INITIAL FIRE SAFETY INSPECTION REPORT

Zalo Knitting Limited

RSC ID: 26394

Date: 29-July-2025

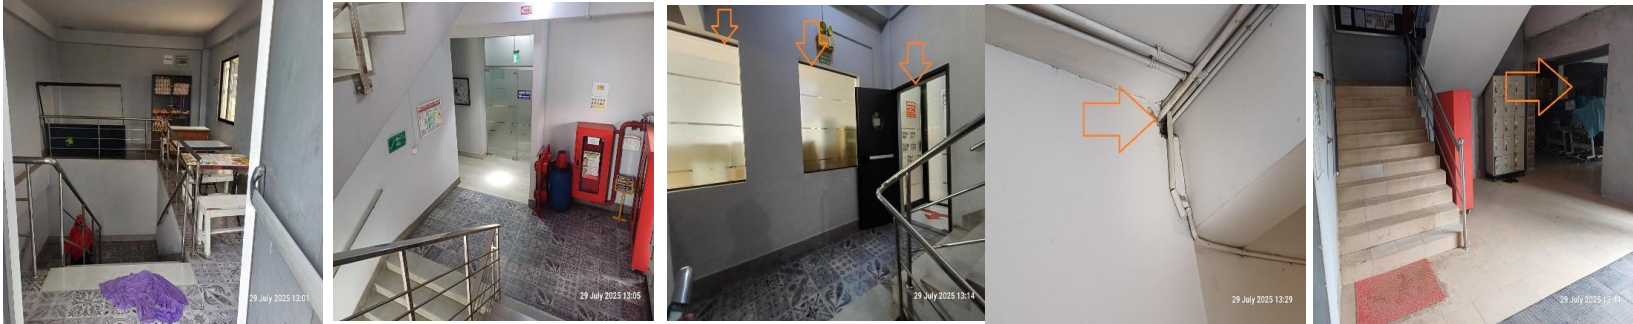
F-2	Fire rated construction.	Areas used for in-process storage of combustible materials are open to the surrounding occupancy. Location: Cutting section on the Ground floor (west part) of main production building.	Provide defined storage areas and limit the storage arrangement as follows: Maximum height of 2.45 m and maximum area of 23 m² and is separated by a minimum 3.0 m (10ft) from other storage areas and they do not exceed 10 percent of the building area of the story in which they occur. If sprinkler protected, Maximum height 12 ft (3.66 m) and maximum area of 1000 ft² (93 m²) and separated by a at least 25 ft (7.62 m) from other storage areas and does not constitute more than 10 percent of the building area or 4000 ft² (372 m²) of the sprinklered area, whichever is greater. or, Enclose the storage area from the surrounding occupancy with a minimum 1 hour fire rated construction.	Within 3 months

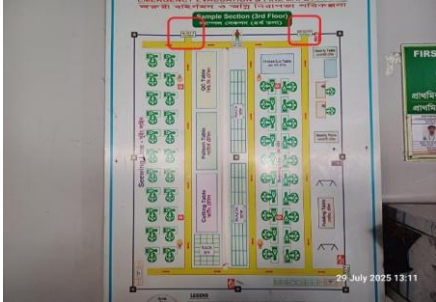
F-5	Fire Rated Construction	Penetrations through floor/ceiling assemblies are found unsealed. Location: Main production Building, All floors, at the west side of the building Non-compliance reason: BBT riser & PVC Plumbing pipe	Seal all penetrations and openings in floor/ceiling assemblies by a listed through-penetration fire stop system tested in accordance with ASTM E814 or approved alternative standard to maintain minimum 3-hr. fire resistance rating. Installation shall be as per manufacturer published installation guideline and the certification authority guideline to ensure the fire-rating in accordance with section 4.7 of RSC Technical Guideline (Standard) Or, Provide a minimum 2-hr fire rated shaft to separate the penetration from each floor if required.	Within 3 months
-----	-------------------------	--	--	-----------------

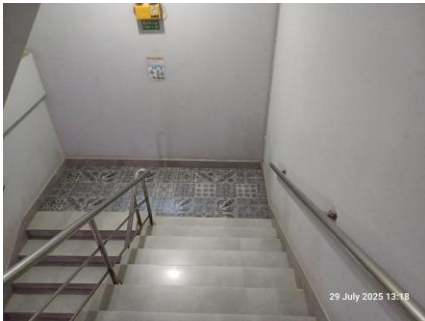
F-9	Means of Egress	The exit stair enclosures are not separated from work areas and other spaces on each floor by fire-rated construction. Location: Main production Building, all floors.	The exit stair enclosure shall be provided with a minimum 1-hr fire resistance rating for buildings with 3 or fewer stories and a minimum of 2-hr. fire resistance rating for buildings 4 or more stories. Provide 1-hr. fire rated door and seal all penetrations and openings by 1 hr. fire rated fire rated barrier construction for building with 3 or fewer stories. Provide 1.5 hr. fire rated door and seal all penetrations and openings by 2 hr. fire rated fire rated barrier construction for building with 4 or more stories in accordance with section 6.3.1.2 of RSC Technical Guidelines (Standard)¹ V1.0. Provide a fire-resistive rated assembly between the exterior exit stairs and the building up to 10 ft. beyond the end of the stair to achieve the required separation. The rated assembly shall be approved and/or designed by a qualified fire protection engineer. Ensure that the fire doors are self-closing and positive latching and that they are provided with fire exit (panic) hardware where serving production floors. If fire doors are required to be held open for functional reasons, provide automatic closing devices tied to the fire alarm system. Keep proper datasheet & certifications for installed fire doors & accessories on-site for verification. The clearance under the bottom of a door shall be a maximum of 3/4 in. (19 mm).	Within 3 months

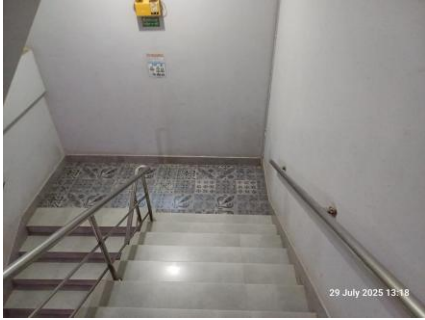
F-10	Means of egress	Storage areas discharges directly into the exit stair enclosure without inclusion of vestibule. Location: Stair-2 enclosure on 3rd floor, Stair-2 and Stair-3 enclosure on ground floor of Main production building.	Openings from exit enclosure to Storage areas/ basements/ transformer rooms/ generator rooms/ boiler rooms and similar normally unoccupied spaces shall be provided with a vestibule with fire rated construction and openings in accordance with section 6.14.3 of RSC Technical Guidelines (Standard)¹ V1.0. Provide a min 1-hr fire rated door on the exit stair side and a 1.5 hr. fire rated door on the Store, generator, sub-station room side . Ensure that the fire rating of the vestibule construction matches that of the exit stair enclosure as per RSC Technical Guidelines (Standard)¹ V1.0. section 6.14.3. The minimum width for vestibules shall not be less than 1.1m and length 1.8m.	Within 3 months

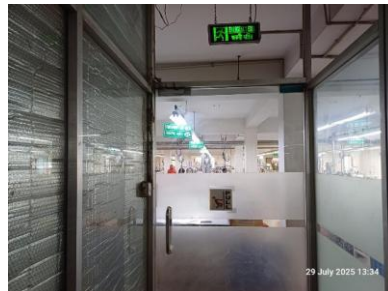
F-12	Means of egress	The sample section located on the 3rd floor of the main production building with an occupant load more than 50, is provided with two exits. But the exits are not remotely located from each other such that a single fire event could compromise both exits. Location: 3rd floor of Main production building.	Provide additional exit or reconfigure the exit arrangement to ensure that the exit doors or means of egress openings are located a distance apart as per RSC Technical Guideline (Standard) section of 6.6.6.	Within 3 months

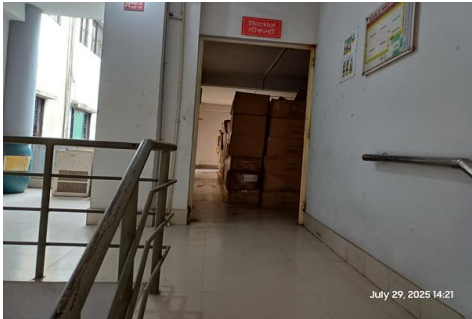
F-26	Means of Egress	Fire evacuation maps is not posted at the entrance of all exit stair. Location: All floors of Main production Building.	Fire evacuation maps shall be posted at the entrance to each exit stair in accordance with RSC Technical Guidelines (Standard)¹ V1.0 Section 13.3.	Within 1 month
F-27	Means of Egress	Building does not have occupant load signs at required locations on all floors. Location: All floors of Main production Building.	Post the occupant load for every assembly and production floor in a facility in a conspicuous space near the main exit or exit access doorway for the space in accordance with RSC Technical Guidelines (Standard)¹ V1.0 Section 6.4.4.	Within 1 month
F-28	Means of Egress	Building does not have stair/floor level designation signs at required locations on all floors. Location: All floors of Main production Building.	Provide stair designation sign at each floor entrance from the stair to the floor in English and Bengali. Signs shall indicate the name of the stair and the floor level. Signs shall be posted adjacent to the door in accordance with RSC Technical Guidelines (Standard)¹ V1.0 Section 6.9.3.	Within 1 month

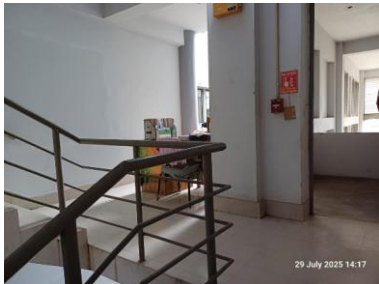
Sl No.	Category	Findings	Required Action	Remediation Time Frame
F-36	Fire Rated Construction	The required fire separation distance for Shed-01 does not comply with the requirements of BNBC. Location: Shed-1: Bonded warehouse	The “Ministry of Housing and Public Works” has issued a resolution based on the recommendations from House Building Research Institute (HBRI) and Public Works Department (PWD) to assess structural fire protection requirements of steel buildings (unprotected non-combustible construction type) according to BNBC 2020. The exterior walls shall have a fire resistance and opening protection as specified in BNBC 2020 Part 3 Table 3.2.2 & 3.2.3 and BNBC 2020 Part 3 Section 2.4.1.3.	Within 6 months
